Community for Accurate Impact Assessment of the Dalton Power Station (CAIAD)  
"Altjira"  
Alton Hill Road  
Gunning NSW 2581  
Correspondence to: amakeig@bigpond.net.au

Director, Resource Assessments  
Department of Planning and Environment  
GPO Box 39  
Sydney NSW 2001

April 13, 2017

**SUBMISSION IN RESPONSE TO THE DALTON POWER PROJECT - REQUEST TO EXTEND LAPSE DATE**

**Figure 1: Original and actual images of the Dalton power station**

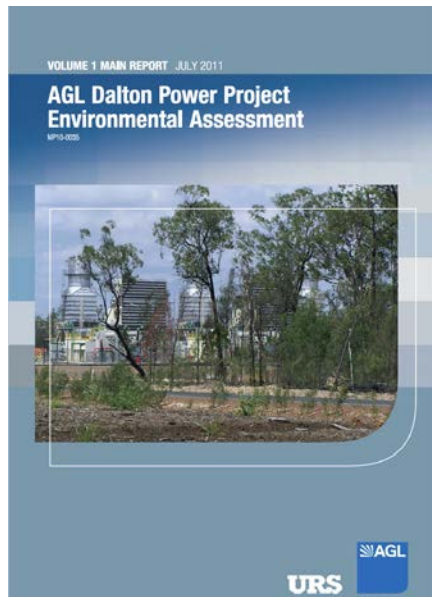
AGL has conducted itself appallingly in the approval process. From the outset they have sort to deceive and underplay the impact of power station on the community. One of the requirements of the Director General is that the proponent consults with the community. AGL has failed to do this. Unbelievably the picture on the front of the EA wasn't even a image of the Dalton power station, rather it was an image of the much smaller Leaf's Gully power station (see Figure 1).

For many in the community their review of the project amounted to looking at the front cover of the EA. To put an incorrect image on the cover is unforgiveable. For this reason alone the project should have been rejected.

Figure 2: Lot boundaries - Dalton April 2017, AGL property 'yellow', new subdivision 'pink'

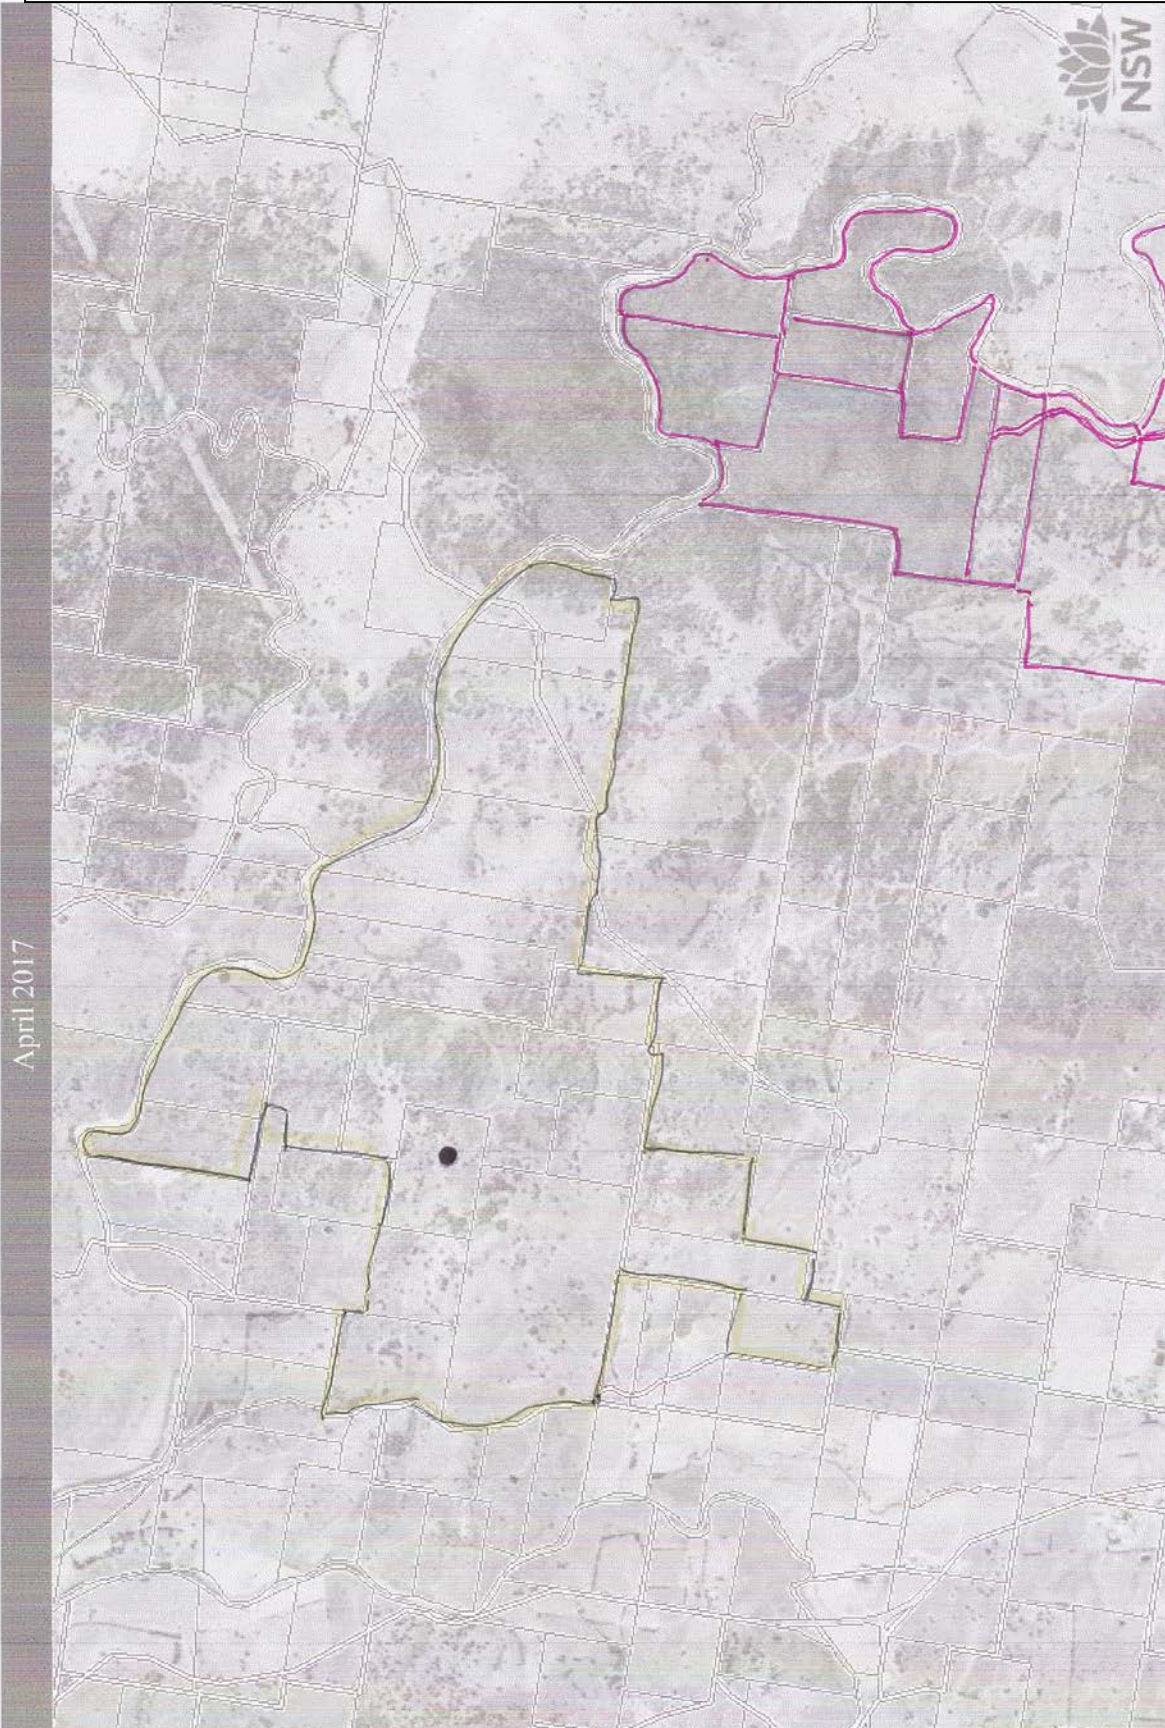
There have been significant demographic changes to the region since October 2012 when AGL announced the suspension of the DPP. A subdivision has gone ahead in close proximity to the proposed site and there are some 18 new impacted people in the community. There is real risk that the power station will exceed the NSW INP criteria at these new properties (see Figure 2: Lot boundaries – Dalton April 2016– yellow highlighted DPP property, pink new Lots). The *MAJOR PROJECT ASSESSMENT: Dalton Power Project Walshs Road, Dalton (MP10\_0035)* by DP&I in Table 13 indicates the night time criteria will be exceeded for nearby receptor J. This is expected to be a significant underestimate of the actual exceedances at these new properties. The exceedances reported in Table 13 occurred even though the noise assessment failed to model adverse weather conditions specific to the region, and the amplification from modelled adverse conditions was well below the 5-10dB, that the NSW INP policy says occurs on average.

See Figure 2 below.

Figure 3: Goulburn weather – inversions and average wind speed

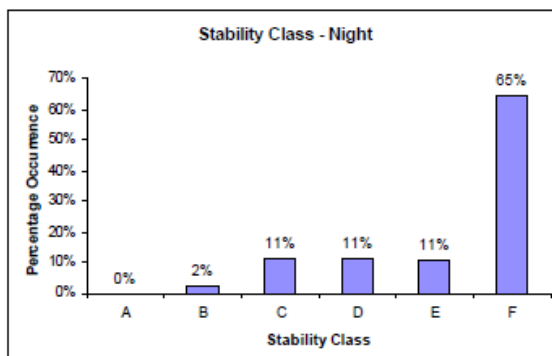
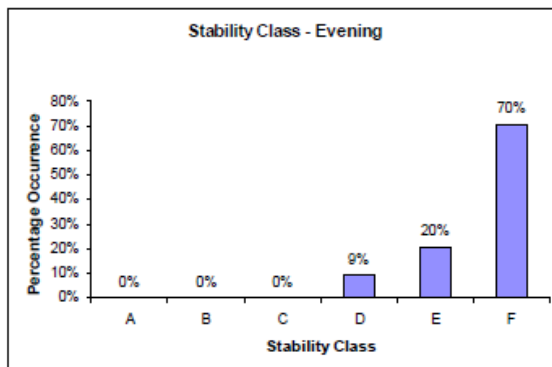
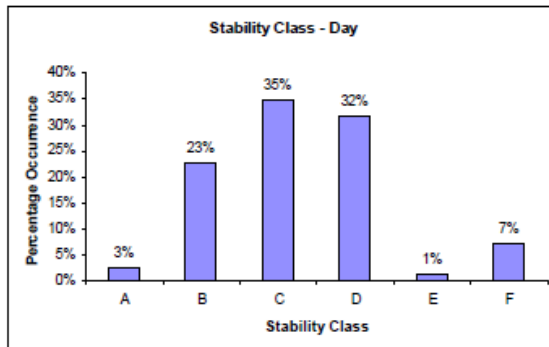
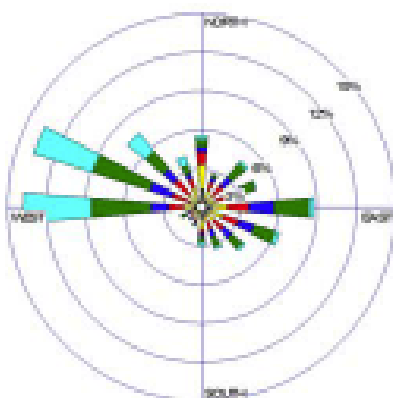
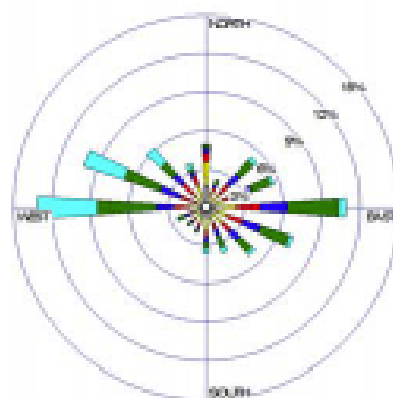
As no weather data was available at Dalton, in the EA weather from Goulburn was used. The community successfully argued that the weather at Dalton is significantly different to Goulburn and so consent condition C45 was required.

The Goulburn weather data showed that in the evening and night F class temperature inversions occurred for 65-70% of the time and average wind speeds every year from 1999 to 2006 exceeded 4m/s (14km/hour) (see Figure 3 below).

These conditions were modelled by AGL/URS as adverse weather conditions of the region. However they are in fact average weather conditions of the region (see Table 5-1 Prevailing meteorological conditions; and Table 5-5 Meteorological Conditions used in Noise Modelling, below).

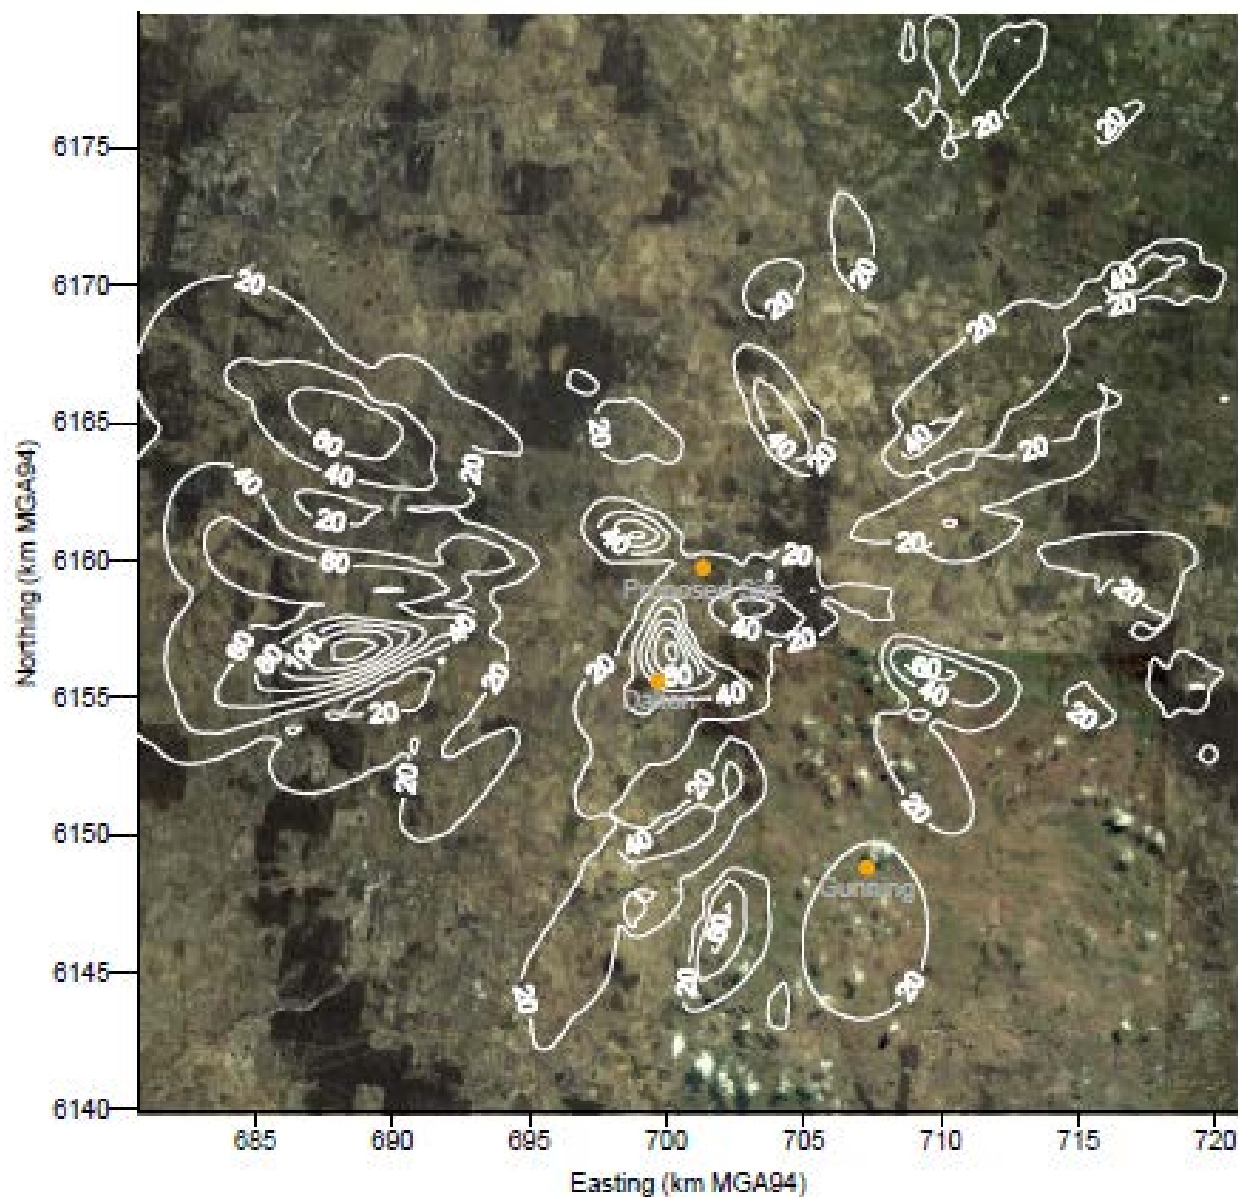
So the maximum cumulative 1 hour level of  $240.7 \mu\text{g}/\text{m}^3$   $\text{NO}_2$  for the Dalton power station significantly breaches the 1 hour level temperature-adjusted Australian standard as well as the level the WHO considers safe for human health. The annual level is only just below the WHO standard to prevent adverse health effects. Also the manufacturer says for the turbines GE 9FA,  $\text{NO}_x$  emissions exceed 25 ppm.<sup>1</sup> AGL says all manufacturers guarantee emissions of 25 ppm when operating at over 50% load (AGL and URS 2011, p3-62).

When you Google what a  $\text{NO}_2$  measure of 200 plus means it say ‘stay indoors and avoid physical exercise’. Not very helpful for farmers working outdoors and doing physically strenuous work!

See below the areas impacted by the air pollution.
